# Access Compliance Report

## Public Rights-of-Way

Intersection ID: 49702	Main Street: SCOTTSMAN_TRACE_DR	Cross Street: MILL_RIVER_LN	Location: NE
ADA ID: 9A926A22D9A3	Ramp Type: BlendTrans1	Initial Pass/Fail: Fail	Overall Compliance: No
Codes/Mitigation Info/Possible Solution		Field Measurements/Component Compliance	
Severity Score: 8.75

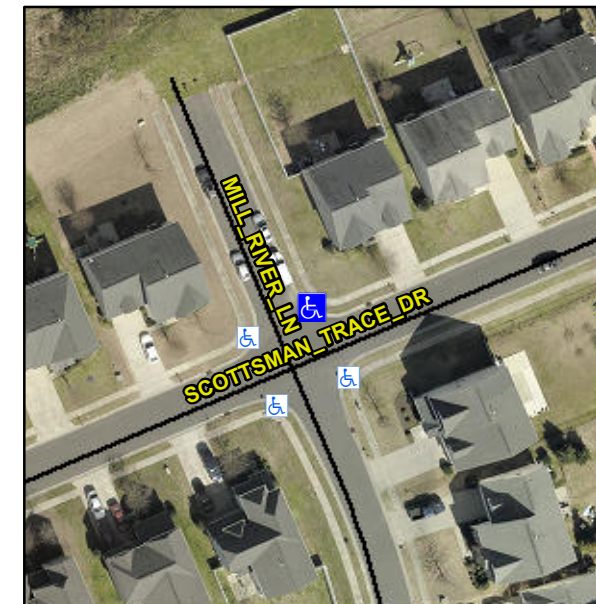
**Not Found, R304.5.1**

Compliance	Description	Data	Compliance	Description	Data
N/A	Ramp Length (in)	48.0	Yes	BlendTrans Slope (%)	3.7
No	Ramp Width (in)	45.0	Yes	BlendTrans XSlope (%)	1.8
N/A	Flare Type LT	N/A	N/A	Flare Type RT	N/A
N/A	Flare Slope LT (%)	N/A	N/A	Flare Slope RT (%)	N/A
N/A	Flare Traversable LT?	N/A	N/A	Flare Traversable RT?	N/A
N/A	Landing Length (in)	N/A	N/A	DWS Provided?	N/A
N/A	Landing Width (in)	N/A	N/A	DWS Contrast?	N/A
N/A	Landing Slope (%)	N/A	N/A	DWS Length (in)	N/A
N/A	Landing X Slope (%)	N/A	N/A	DWS Full Width?	N/A
N/A	Landing Curb? (Y/N)	N/A	N/A	DWS Offset (in)	N/A
N/A	Shared Landing?	N/A			
N/A	Gutter Ponding?	N/A	N/A	Gutter Slope (%)	N/A
N/A	Gutter Lip Ht (in)	N/A	N/A	Gutter X Slope (%)	N/A
N/A	Painted X Walk1?	No	N/A	Painted X Walk2?	No
	X Walk 1 Direction	To SW		X Walk 2 Direction	To SE
	X Walk 1 Width (in)	N/A		X Walk 2 Width (in)	N/A
	X Walk 1 Slope (%)	1.2		X Walk 2 Slope (%)	3.6
	X Walk 1 X Slope (%)	0.8		X Walk 2 X Slope (%)	3.1

N/A	Ramp inside XWalk1?	N/A	N/A	Ramp inside XWalk2?	N/A
	Road Slope (%)	3.6		Clear Space?	N/A
	Road X Slope (%)	2.0	N/A	Clear Space to XWalk (in)	N/A
N/A	Any Obstructions?	N/A	N/A	Storm Grate/Utility Hazard?	N/A
	Obstruction Type			Storm Grate/Utility Type	
		N/A			N/A
			Yes	Surface Condition? (G/P)	Good
			No	Curb Slope (%)	9.3

**Remove & Replace Curb Ramp With Two New Directional Ramps or Equivalent.**
